Service Advisory SA-0002

Subject: Cabin Environmental Controller

ATA-Code: 21-60

Effectivity: K003 and On

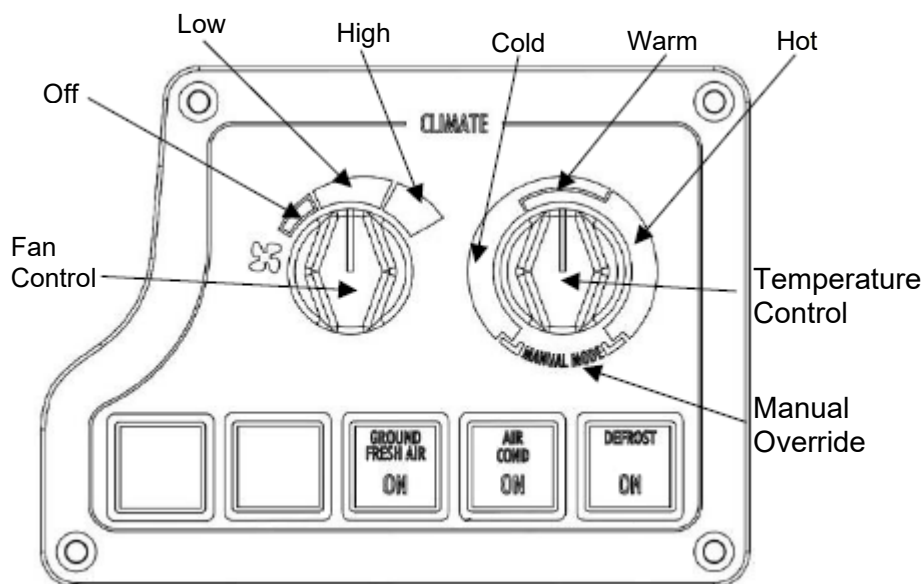
It has been found that using the manual hot or manual cold override may induce a failure into the environmental controller. The purpose of this service announcement is to advise pilots not go past 3:00 or 9:00 position.

Use of the hot or cold manual mode detents has been found, on rare occasions, to induce a failure of the environmental temperature controller. It is recommended not to move the temperature control knob past the 3:00 or 9:00 positions and not to click the controller into the manual hot or cold detent positions to keep the controller operating properly. A service bulletin will be made to fix this issue.
